Fox Run Continuing Care Center JSP18-19

Fox Run CCC Expansion JSP18-19

Fox Run CCC – Phase 4 Preliminary Site Plan
JSP18-19

C101
PSP REVIEW

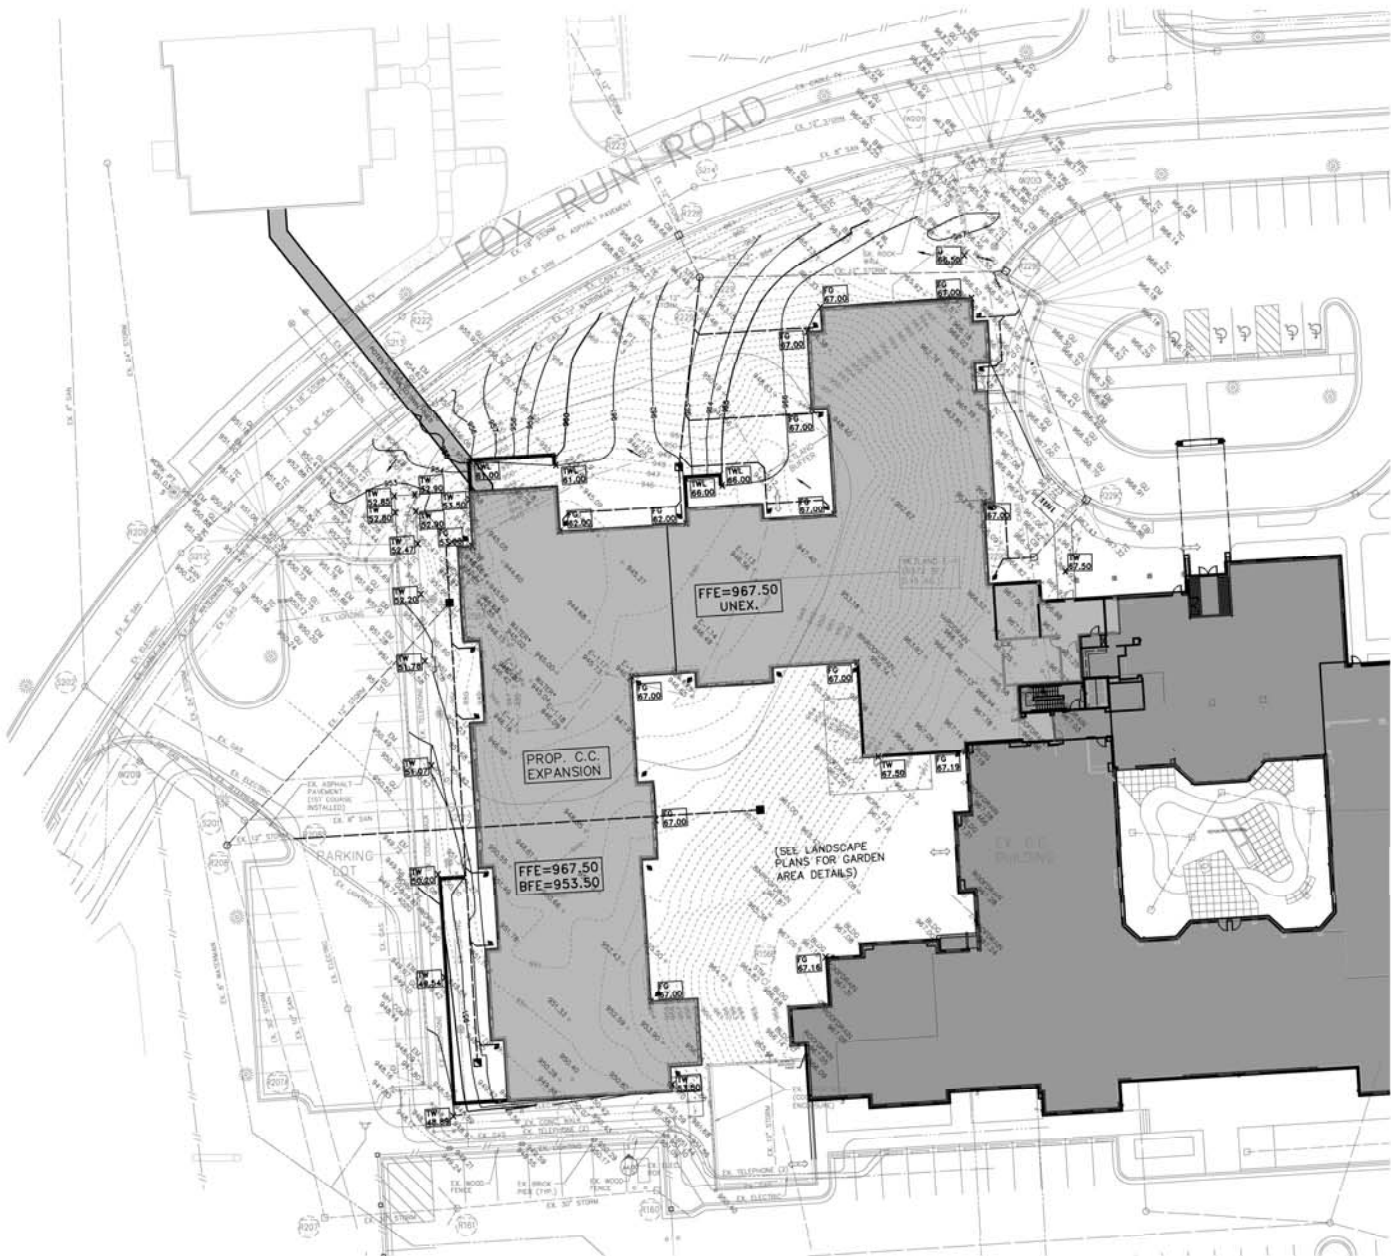
2. Retaining Walls: Heavy black lines on sheets C101, C103, C104, etc. seem to indicate retaining walls on the northern and eastern sides of the building. **Please label these features, both on the site plans and in elevations.**

18. The walls on the engineering plans have been revised to match the walls on the landscape plans. See Sheets C101, C102, C103 and C104.

C103
PSP REVIEW

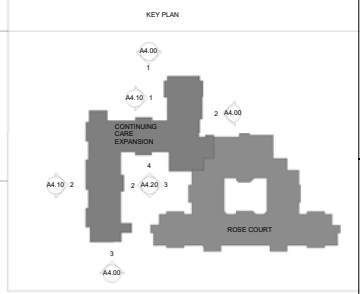
6. Add a gate valve in well to the lead extension.
7. Verify existing finished grade of benchmark hydrant works with surrounding proposed grading. Add any adjustment work to the Utility Plan and Grading Plans.

20. Indicate elevations of finished grades or rims of existing and proposed utility structures on the Grading Plan, specifically the protected light pole near R2, the proposed S1, and the proposed adjustment of the Com MH in the sidewalk.
21. The top lift of asphalt paving shall conform to current paving standards, 1.5 inches of 5E1. Refer to Detail 7C of the current City of Novi Paving Standard Details.

6. A gate valve in well has been added to the water lead extension. Please see Sheet C103.
7. The existing finished grade of the benchmark hydrant shall be adjusted as noted on Sheets C102 and C104.

19. Finished grade elevations at the building corners and transitions have been added to Sheet C103.
20. Elevations on the existing and proposed structures have been added to Sheet C103.
21. The paving specifications has been revised to conform with the city' s current standard.

A4.10
PSP REVIEW

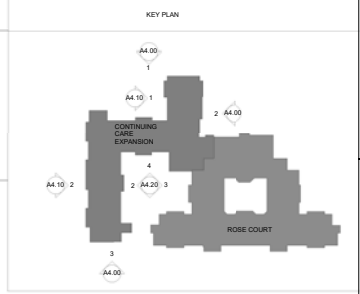
3. Elevation Labels: **The North and South elevations on sheets A4.00 and A4.10 are mislabeled. Please correct.**
4. Photometric Plan: Lighting and photometric plans are required when a project is adjacent to residential areas. **A photometric plan must be included with the next submittal.**
